Planning & Zoning Board

1. App# 2026-0030; 755 S. Waggoner Road; Brad Southard for Havens Corner & Dixon, LLC; Variance

RE: Brad Southard of ACCi; 755 S. Waggoner Road: Variance Application

Date: February 11, 2026
To: Phoenix Buathier, Development Assistant
From: Mitchell Yake, City Engineer
Subject: 755 S. Waggoner Road Variance – Staff Report
Copies: Eric Meyer, Director of Development

CITY OF REYNOLDSBURG, OHIO
VARIANCE REQUEST #1
EXHIBIT A
FOR
BROOKSIDE RIDGE

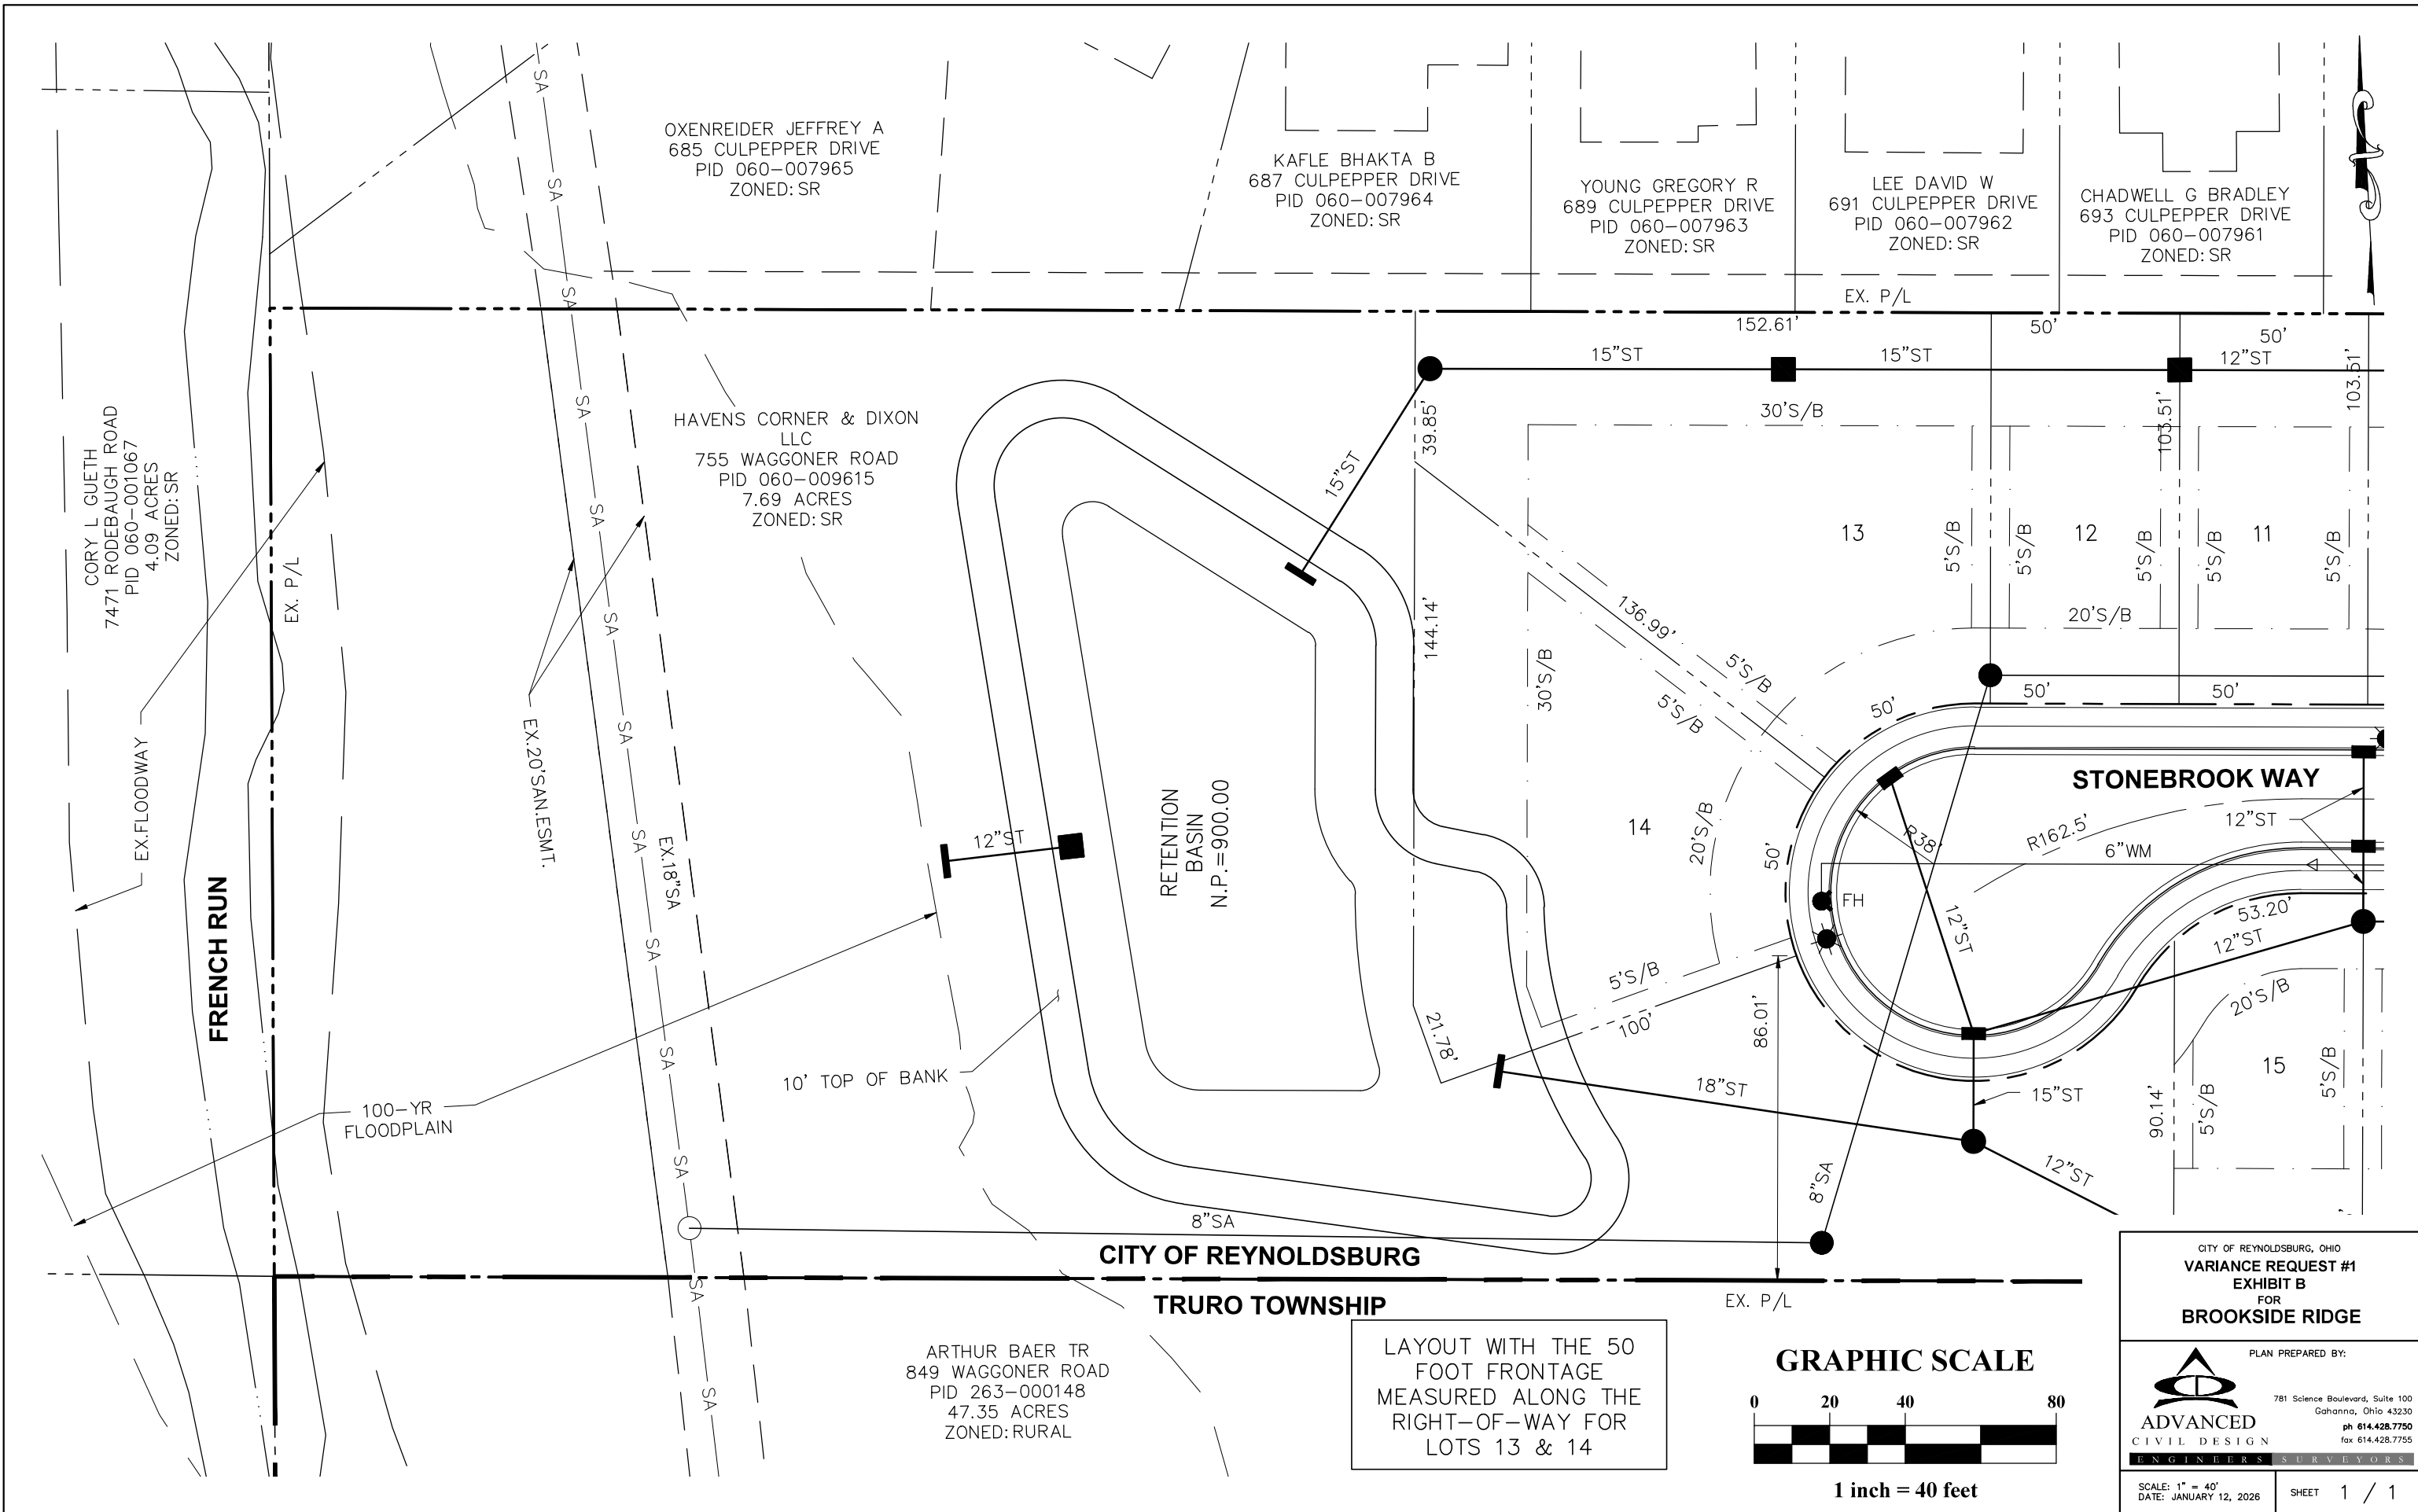
The applicant has provided an alternative site plan showing that if lot 13 and lot 14 were to have 50 feet of frontage, lot 13 could exist without a variance, but lot 14 would fall within the retention basin area. Based upon the alternative site plan, lot 14 could then not exist because a house cannot be built in a retention basin. Staff recognizes that retention basins are generally placed on the lowest point of the development, for storm water mitigation. The location of the retention basin is located at the 890-foot elevation, which appears to be the lowest point in the overall development and the lowest point on the west side of the development. The applicant does not specifically call out the retention basin hardship, however, the applicant also does not specifically say how eliminating lot 14 would deprive the property owner of a subdivision with one less lot. That this subdivision could be built without lot 14 and that the variance to Section 1103.17.III.Lot Dimension. Lot Frontage would not be necessary.

Staff does recognize that lot 14, based on either the proposed site plan or the alternate plan, has a practical difficulty of having a lot 14 without granting the lot frontage variance. The applicant however designed the subdivision, and has not identified how lot 14 is necessary to exist, outside of economic hardship, based on the proposed site plan.

The applicant is requesting a variance to reduce the lot frontage for lot 13 and 14 from 50 to 36 (lot 14) and 37 (lot 13) feet. The applicant has provided an alternative site plan showing that if lot 13 and lot 14 were to have 50 feet of frontage, lot 13 could exist without a variance, but lot 14 would fall within the retention basin area. Based upon the alternative site plan, lot 14 could then not exist because a house cannot be built in a retention basin. Staff recognizes that retention basins are generally placed on the lowest point of the development, for storm water mitigation. The location of the retention basin is located at the 890-foot elevation, which appears to be the lowest point in the overall development and the lowest point on the western side of the development. Meaning that if lot 14 were to be located in the alternative option, it would be located in the necessary retention basin area. The applicant does not specifically call out the retention basin hardship, however, the applicant also does not specifically say how eliminating lot 14 would deprive the property owner of a subdivision with one less lot. If the 24-lot subdivision was found to be necessary for hardship reasons, then the variance reducing the lot frontage for lot 13 and 14 would be necessary based on staff's opinion.
